D206-642-241
Job Sheet 171301

Part Name: Replacement Skidtube, High Gear with Standard Wearplates Fits LH or RH

DRAWING NO. D2650	TITLE 206/407 SKIDTUBE ASSEMBLIES	REV. F	DART AEROSPACE LTD ENGINEERING ORDER		D.E.O. NO. D2650-F-1	SHEET NO. SHEET 1 OF 1	SCALE NTS
DRAWN <i>[Signature]</i>	CHECKED <i>A.P.</i>	MFG. APPR. <i>[Signature]</i>	APPROVED <i>[Signature]</i>		DE APPR. <i>[Signature]</i>		
DATE 12.10.12	DATE 12.10.22	DATE 12.10.22	DATE 12.10.22		DATE 12.10.22

CHANGE C'BORED WELDED CROSSBOLT SPACERS TO SWAGED SPACERS

DETAIL D
FOR Ø0.375 HOLES ONLY
SCALE 3X

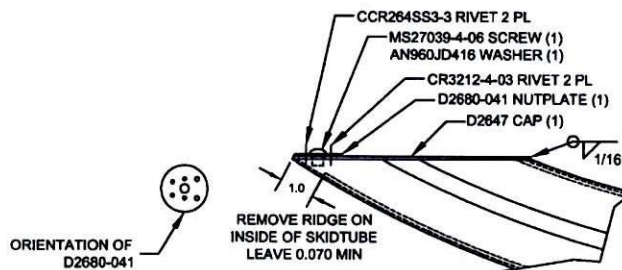
ADD DETAIL G BELOW, WHICH IS THE SAME SECTION VIEW AS DETAIL D OF DWG.
C'BORED HOLES ARE NOW SWAGED PER DETAIL G BELOW. FOR THE Ø0.375 HOLE THAT IS NOT C'BORED, WELD PER DETAIL D OF DWG (SEE AMENDED DETAIL B FOR REFERENCE).
